**PLANNED UNIT DEVELOPMENT  
& SUBDIVISION STAFF REPORT****Date: April 5, 2012****DEVELOPMENT NAME**

Charter Southland Hospital

Charter Southland Hospital Subdivision, Resubdivision of Lot 1, Resubdivision of Lots 1 &amp; 2

Planned Unit Development Approval to allow multiple buildings on a single building site, and Subdivision approval to create one legal lot of record.

## SITE PLAN

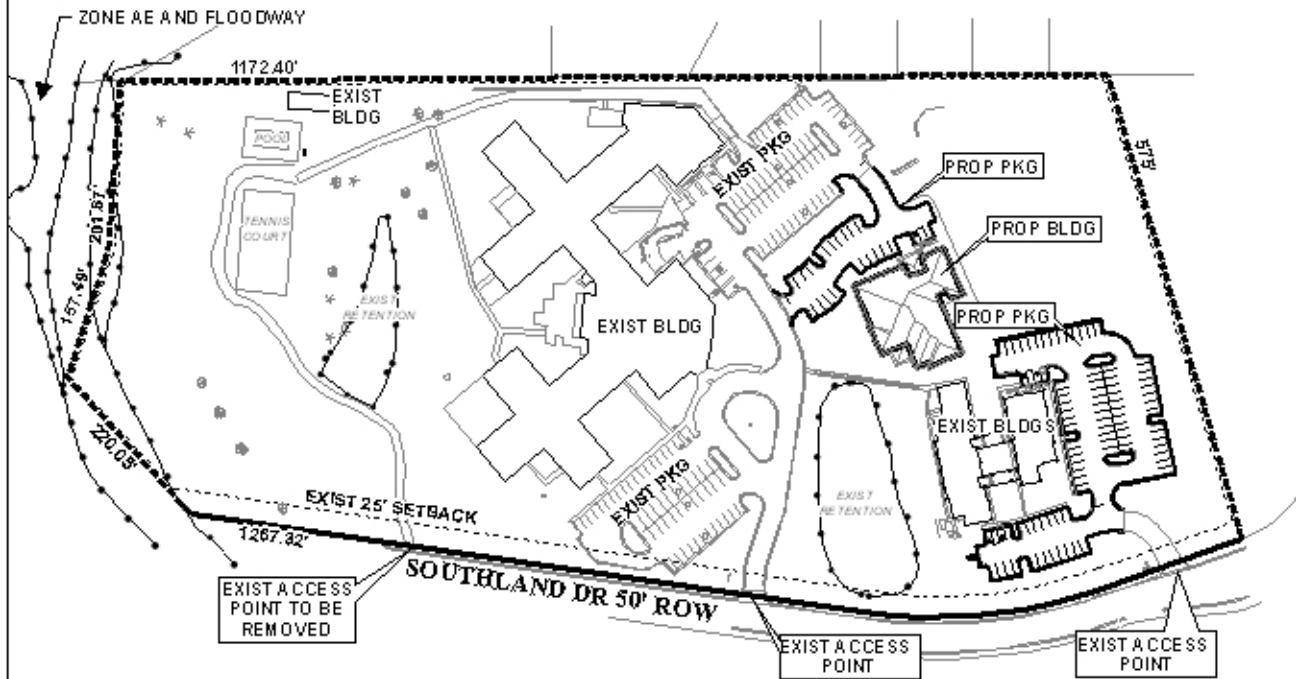
The applicant has submitted a site plan illustrating the placement of the various buildings and amenities, parking, and landscaping and tree plantings. However, there is no table furnished providing parking requirements for the various buildings based on the uses of the buildings; therefore, the site plan should be revised to provide parking requirement calculations. Also, the site plan does not indicate any dumpster locations; therefore, the site plan should be revised to illustrate compliant dumpster locations. As the site is bordered on the North entirely by Leesburg Subdivision, an R-1, single-family residential development, a protection buffer should be illustrated; therefore, the site plan should be revised to illustrate a protection buffer in compliance with Section 64-4.D.1. of the Zoning Ordinance. And as the site is adjacent to R-1

zoning and use, lighting of the parking area and site must comply with Sections 64-4.A.2 and 64-6.A.3.c of the Zoning Ordinance, and the site plan should be revised to provide such a note.

As the Subdivision would require dedication to provide a 60' radius turnaround from the centerline of Southland Drive at its Western terminus, the PUD site plan should be revised to illustrate such a turnaround. And the site should be limited to two curb cuts to Southland Drive with the size, location and design to be approved by Traffic Engineering and conform to AASHTO standards. The existing gravel drive on the Western portion of the site beyond the existing asphalt drive appears to be for maintenance purposes only but its use is not specified on the site plan. The gravel drive should be identified as for maintenance purposes only on the site plan or the site plan should be revised to indicate the drive paved to standards. The site plan indicates the existing access point to Southland Drive for the gravel drive is to be removed; however, the site plan should be revised to indicate termination short of Southland Drive or the installation of some type of vehicular barrier across the drive preventing access to Southland Drive.

- 1) revision of the site plan to provide parking requirement calculations based on the uses of the various buildings;
- 2) revision of the site plan to illustrate compliant dumpster locations;
- 3) revision of the site plan to illustrate a protection buffer along the North property line adjacent to Leesburg Subdivision, in compliance with Section 64-4.D.1. of the Zoning Ordinance;
- 4) revision of the site plan to provide a note stating that lighting of the site will be in compliance with Sections 64-4.A.2 and 64-6.A.3.c of the Zoning Ordinance;
- 5) revision of the site plan to illustrate the 60' radius turnaround dedication at the West terminus of Southland Drive;
- 6) revision of the site plan to label the gravel drive on the Western portion as being for maintenance purposes only, or revision of the site plan to indicate that the drive will be developed to compliant standards; and

- 7) revision of the site plan to indicate termination of the gravel drive short of Southland Drive or the illustration of some type of vehicular barrier across the drive to prevent vehicular access to Southland Drive.
